1970 - 1973 Corvette: Service Bulletin: Overheating - 454 Cu.In. Engine with Air Conditioning

73-T-28

Subject: ENGINE OVERHEAT - 1970-1973
 CORVETTES WITH 454 CU. IN.
 ENGINES AND AIR CONDITIONING

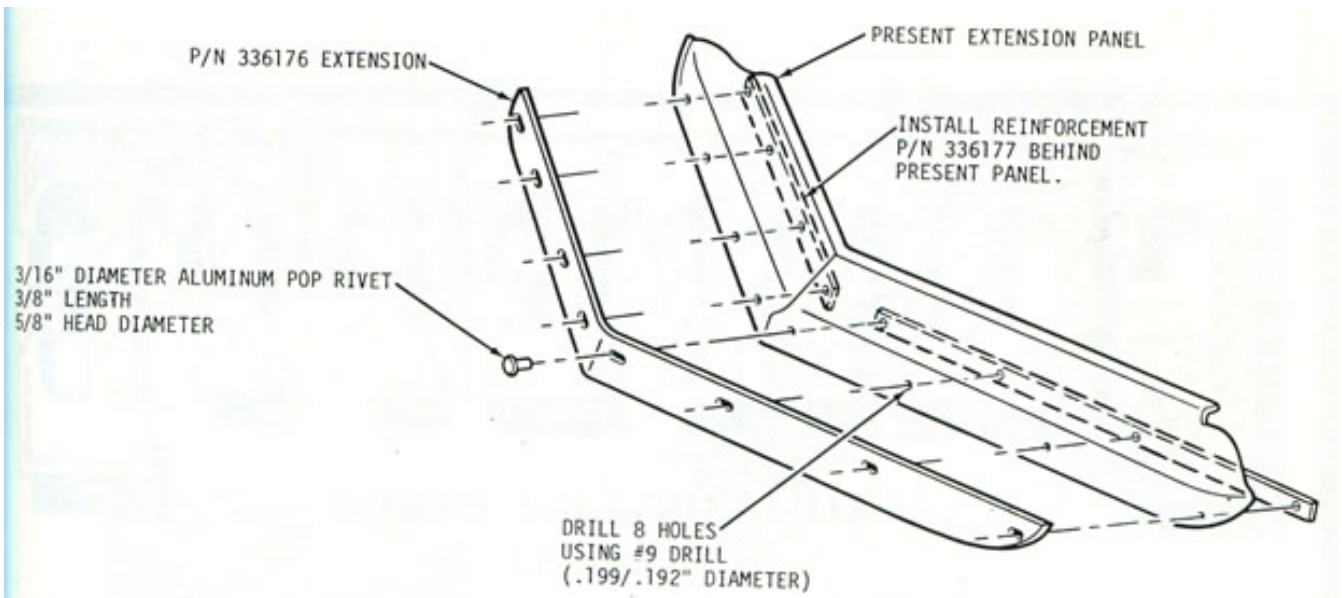
Engine overheat may be encountered on some 1970-1973 Corvettes equipped with the 454 cu. in. engine and air conditioning during high ambient temperatures when operated in heavy traffic. This condition is due to the limited amount of air flowing through the radiator at low vehicle speeds or during periods of extended idle.

To improve low speed cooling, an additional grille panel lower extension was installed in 1973 Corvettes produced after Vehicle Identification Number 1Z37Z3S410722. This extension, Part Number 336176, may be installed as illustrated on page 2 of this bulletin on early 1973 Corvettes only.

In addition, a flex fan that provides increased air flow through the radiator has been released for service use on any 1970-1973 Corvette with 454 cu. in. engine and air conditioning. This fan replaces the original fan and fan clutch assembly and may be ordered in a kit, Part Number 6260480, that includes the necessary attaching parts. When using the flex fan, an increase in fan noise may be noticed under some driving conditions.
